NOTES:

VIEW A-A
3 PLACES, TYPICAL

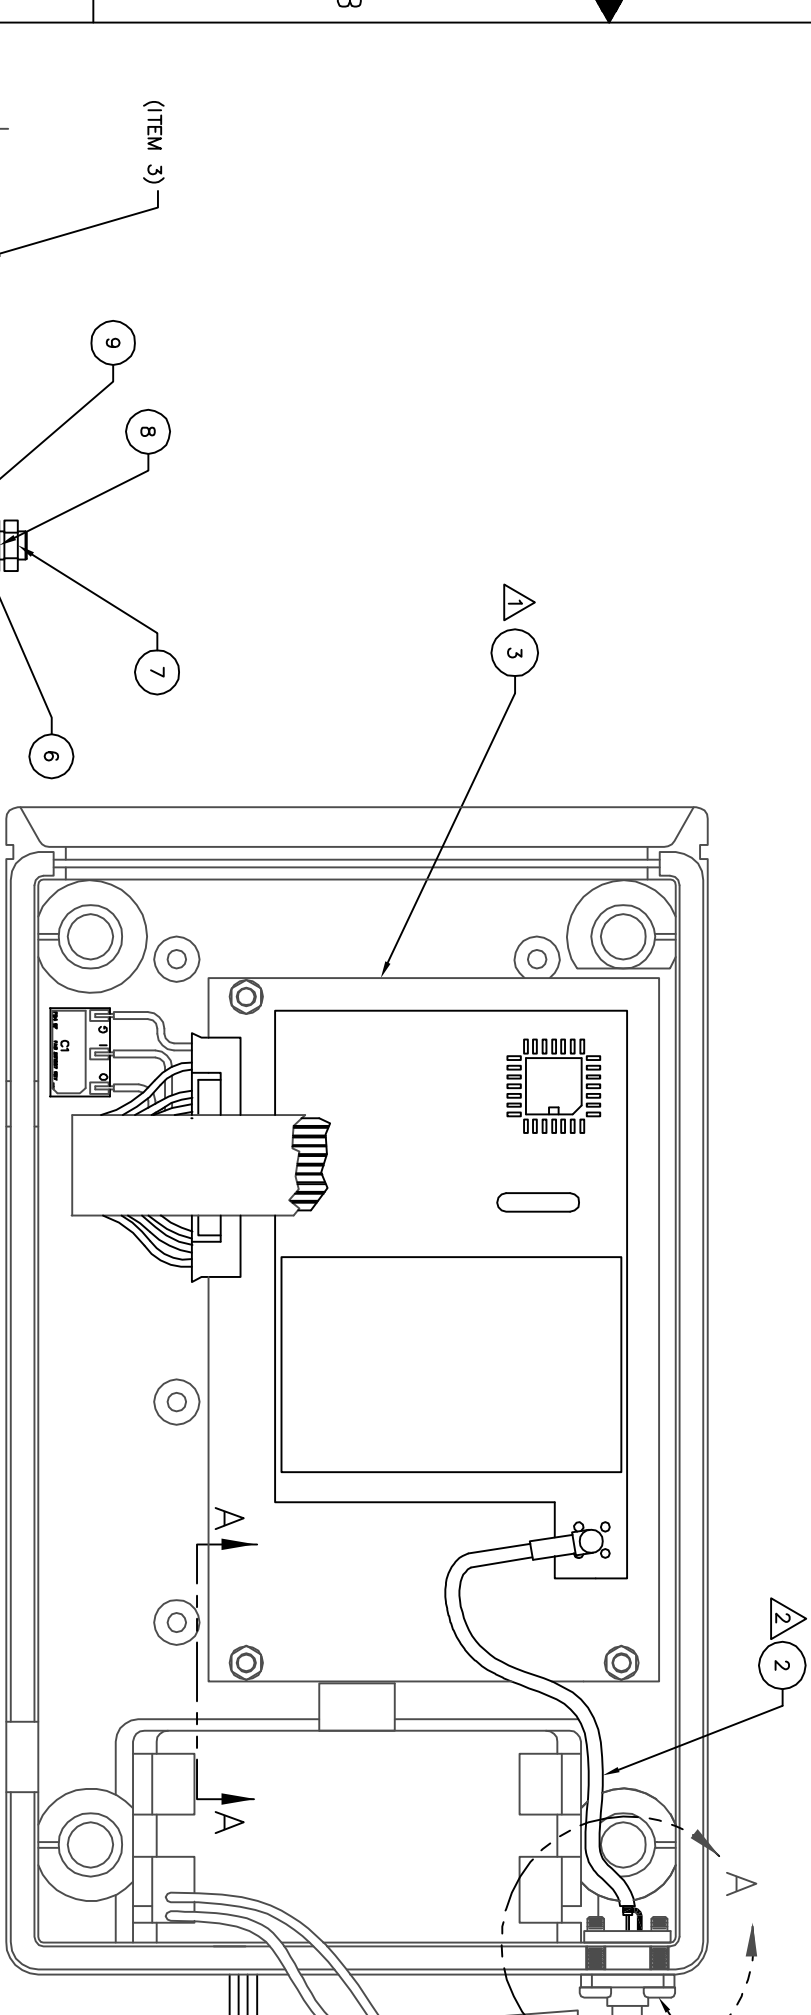
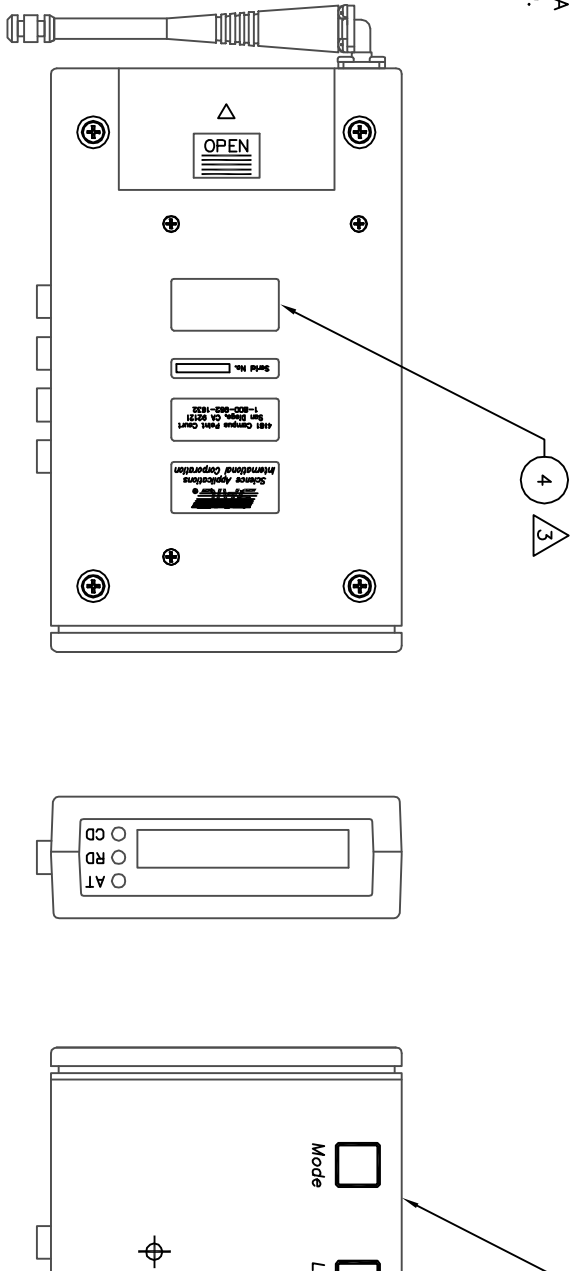
- 1 REMOVE EXISTING PROXIM WIRELESS MODEM AND MOUNTING HARDWARE. REPLACE WITH ITEM 3, PDE-5 PWA PDE-5 PWA AND MOUNTING HARDWARE, ITEMS 5 THRU 9. SEE VIEW A-A, PAGE 2.
- 2 REMOVE EXISTING RF CABLE AND REPLACE WITH ITEM 2, RF CABLE. ROUTE CABLE AS SHOWN.
- 3 APPLY FCC LABEL, ITEM 4 OVER THE EXISTING FCC LABEL.
- 4 REMOVE EXISTING CONNECTOR & ANTENNA AND REPLACE WITH ITEMS 11 & 12, AS SHOWN.
- 5 SOLDER 1AW J-STD-001, CLASS 2, USING ITEM 10.
